# **Metro 78 (LDA20-0066)**

## **(Dec 6, Public Hearing)**

### **Agenda items 3.25-3.28**

# Metro78 West buffer- *purpose and value*

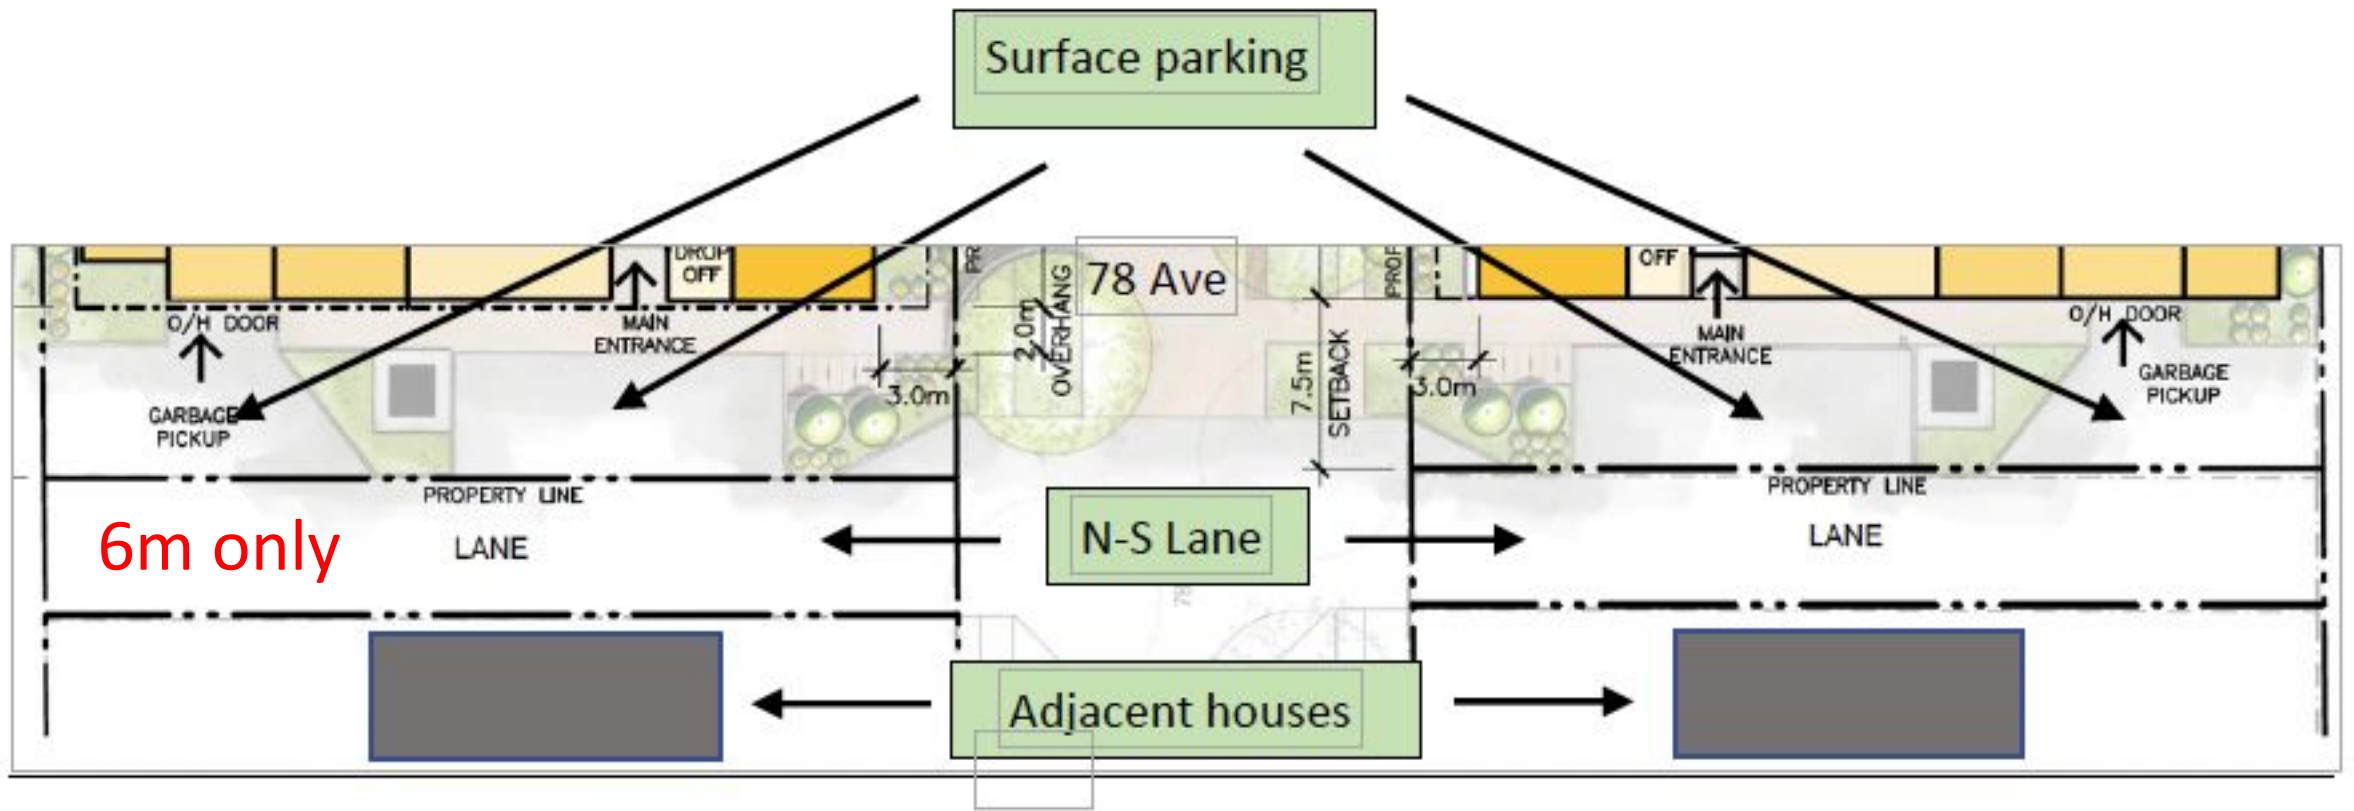
The Metro 78 proposal requires a new N-S lane to be built between 'the development' and the adjacent single detached homes on the west.

- **General vehicle access.** It will connect 78 Ave with the east and west back lanes to allow vehicles access to 115 St
- **Drive-aisle.** Provide access to the Metro 78 surface parking lot.
- **Emergency vehicle access.** Access for emergency vehicles.
- **Sufficient clearance from adjacent homes** (noise, damage, pollution from vehicles to fresh airtakes)

# Metro78 West buffer- *does NOT meet standards*

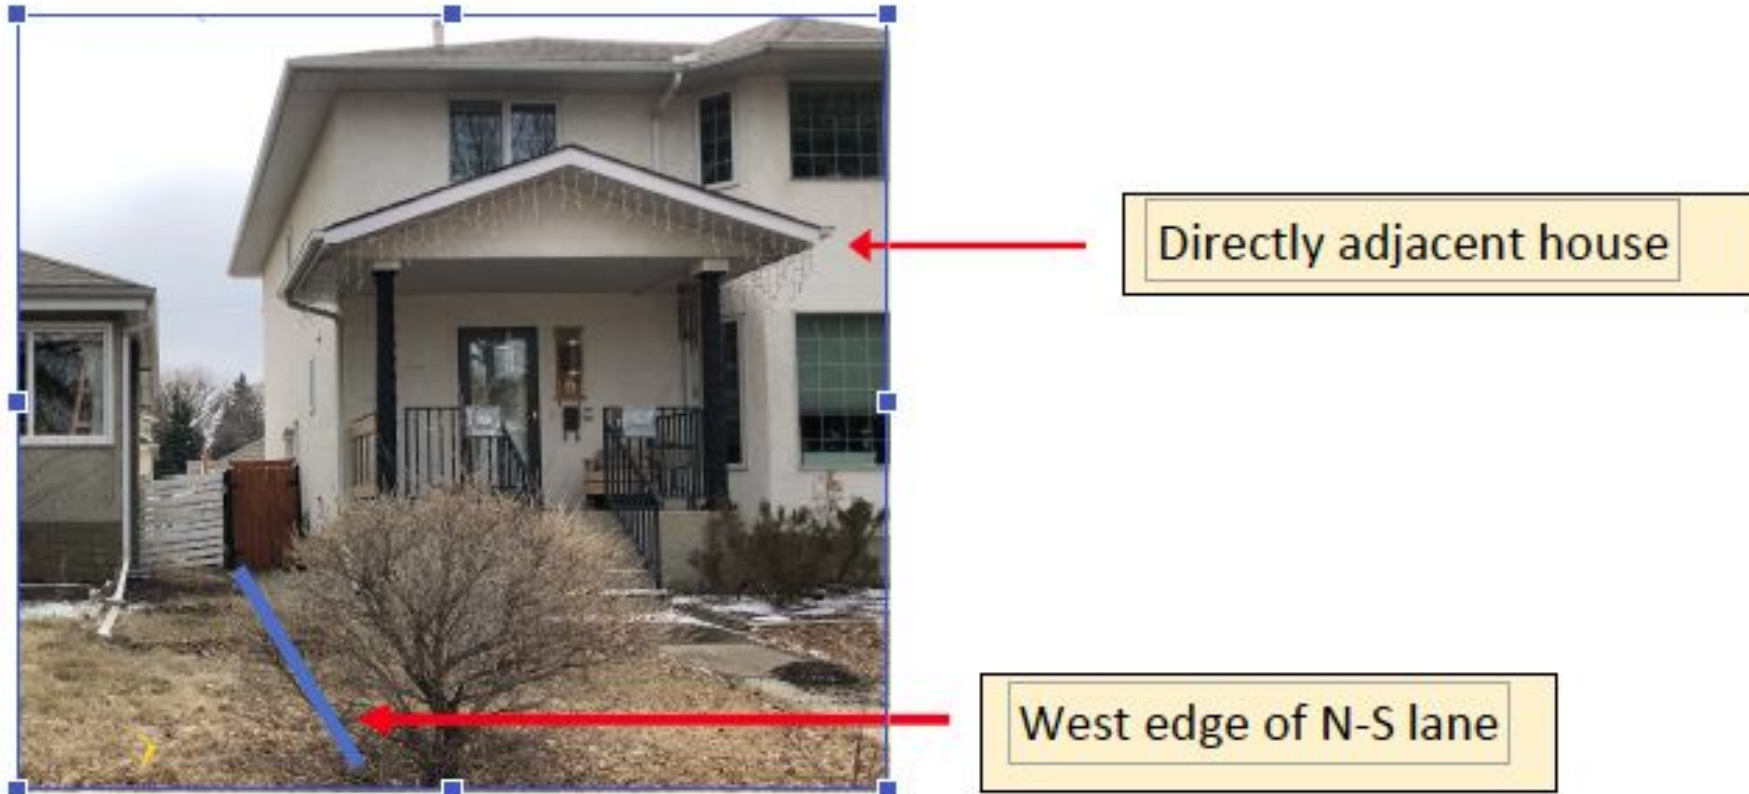
City Design Standards indicate 7.5m for this type of back lane (reverse back lane) to allow for fire trucks (Section 3.9 pg. 170).

City Zoning indicates the drive aisle for a surface parking lot should be 7m (54.1.6.c).

*Current design has the N-S lane as 6m- without any justification?*

Proximity of adjacent housing to N-S lane is a concern for noise, damage, pollution from vehicles to fresh airtake(s).

Provide a minimum 1m landscape buffer between the N-S lane and adjacent west homes (bring the lane to 7.5m). This will not substantially change the build form and allow for the development to meet standards and be conscious of the surrounding community.
